**Environmental
Planning
Commission**

**Agenda Number: 01
Project Number: 1003275
Case #: 16EPC- 40088
February 9, 2017**

Staff Report

Agent	
Applicant	Nathan Bisch- One Architecture
Request	Site Development Plan for Building Permit
Legal Description	Tract A-2, Heritage Marketplace
Location	SW corner of Ladera Drive and Market Street
Size	.94 acres
Existing Zoning	SU-2/SU-1 Planned Office Park and Commercial Development to Include Full Service Alcohol Sales with a Sit Down Restaurant
Proposed Zoning	Same

La.01

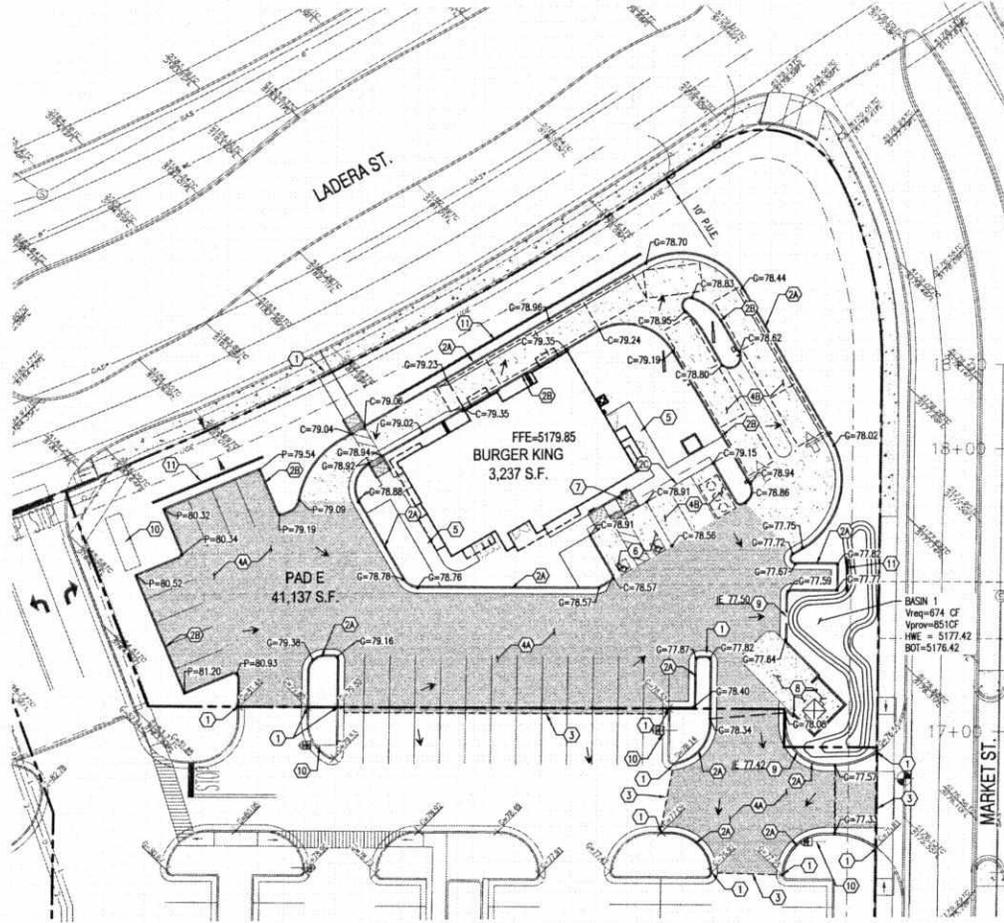
4. Update sheet La.01 to show corrected site square footage and required landscape.
5. Reduce screen wall height to 36 inches to comply with the approved Site Development Plan for Subdivision.

- 1) Place enclosure at a straight shot for refuse driver. Move north.
- 2) Do not plant anything next to enclosure that will create an overhang. Pg. LA.01
- 3) All new /proposed refuse enclosures must be built to C.O.A min spec requirements, including sanitary drain for food services.
